# Addendum / Addenda

## M36 MCC Replacement

Solicitation No./N° de sollicitation	Project No./N° de projet	W.O. No./N° d'ordre de travail
18-22059	5571	A1-011393-06-01
Departmental Representative / représentant ministériel	Date	
Kirk Williams		October 26, 2018
Notice:	Nota:	
This addendum shall form part of the tender documents and all conditions shall apply and be read in conjunction with the original plans and specifications.		Cet addendum fait partie intégrale des dossiers d'appel; toutes les conditions énoncées doivent être lues et appliquées en conjonction avec les plans et les devis originaux.

dwg.no.  
**5571-SKE01**

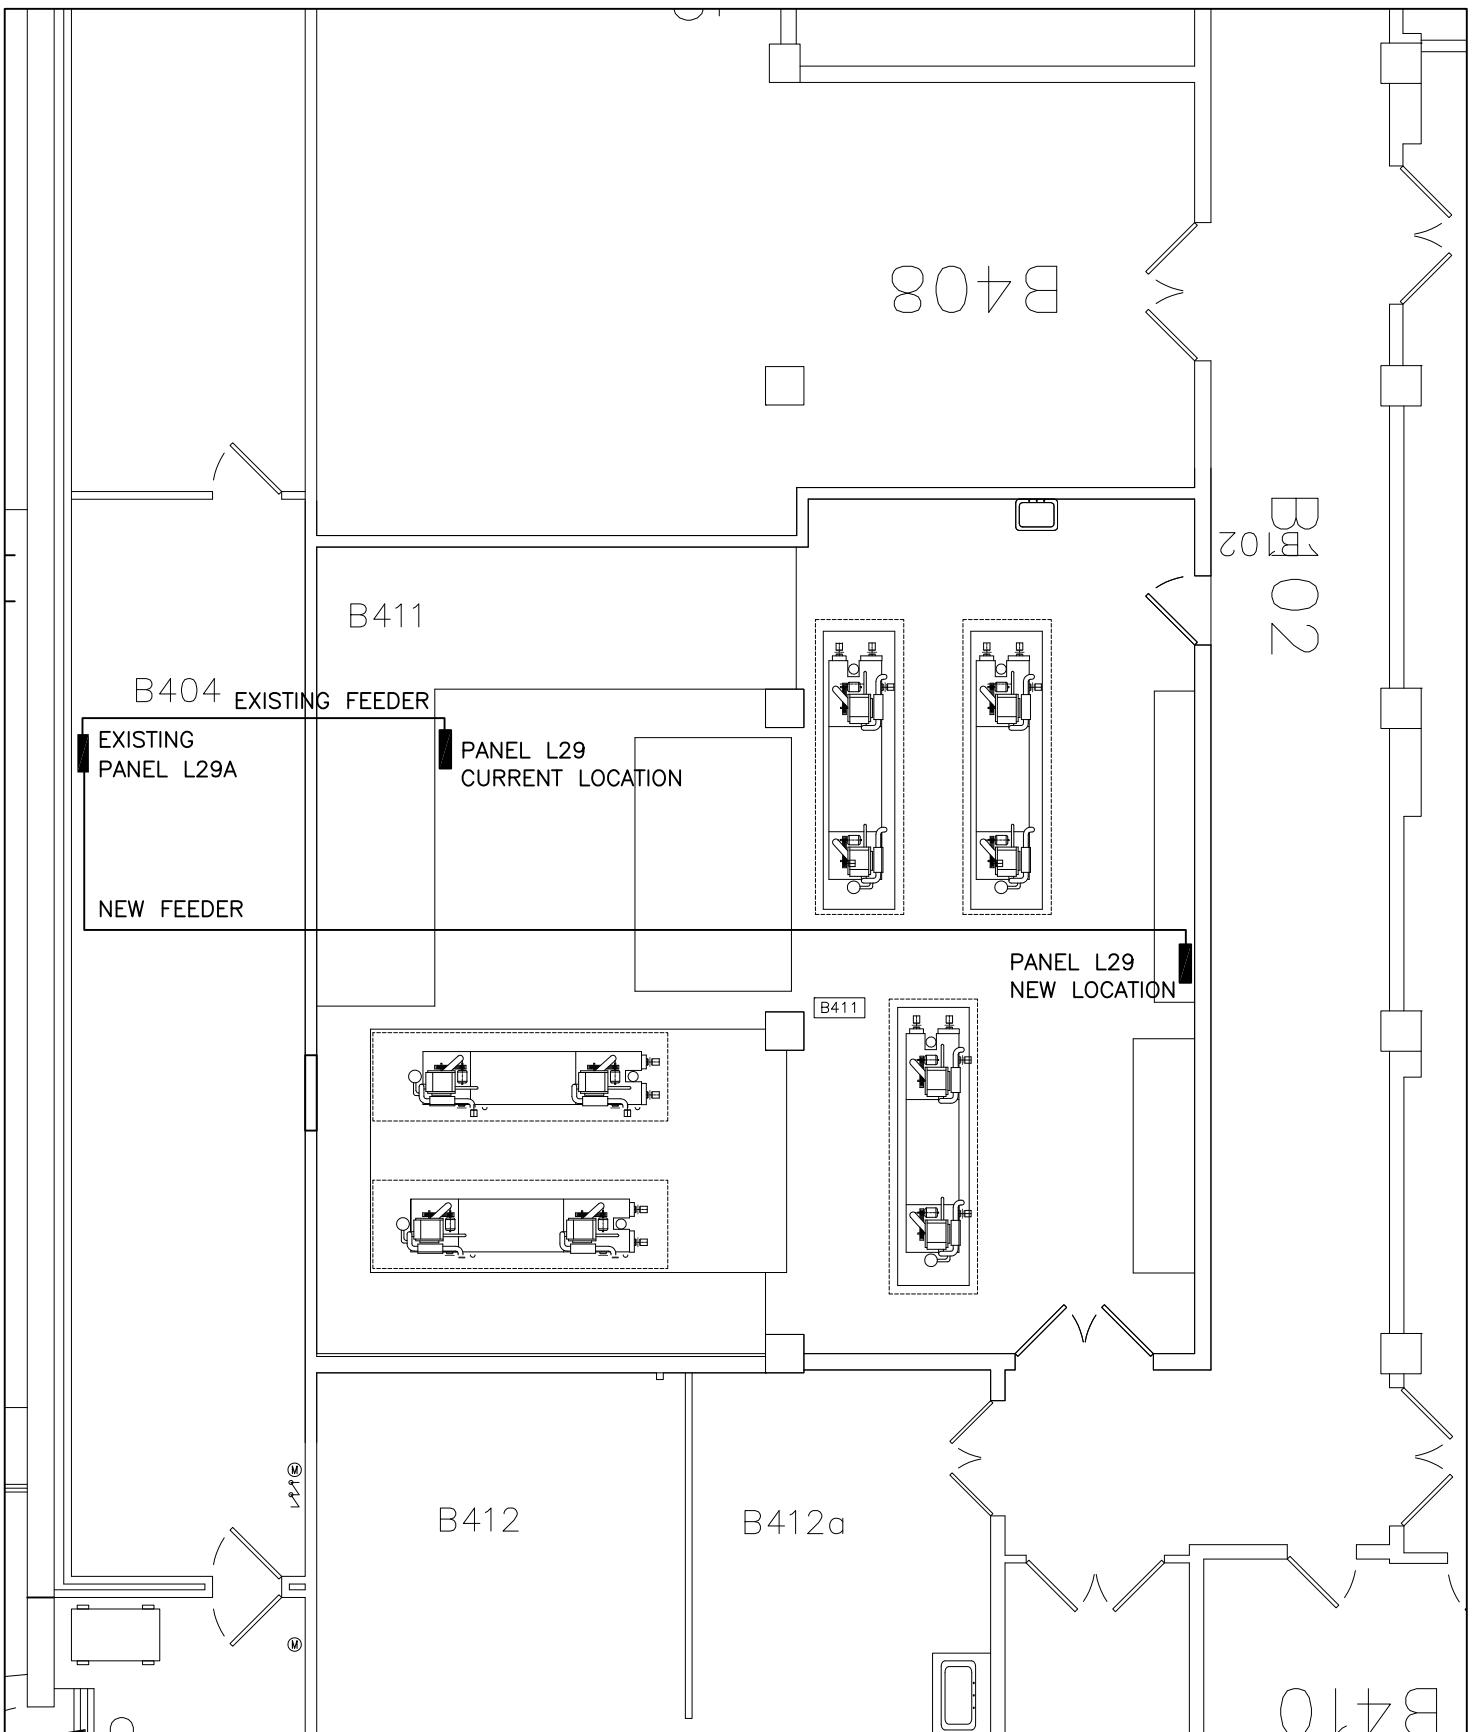
- 6 Attached is the job showing attendance sheet.
- 7 A new panel called L29A was recently added and fed from panel L29. Refeeding this panel is to be part of the relocation of L29. Attached sketch shows the location of panel L29A. As part of your bid include provided a feeder from the new location for panel L29 to panel L29A. Feeder is to be 3 #8 + ground in EMT. Provide a 2P40A breaker in panel L29.
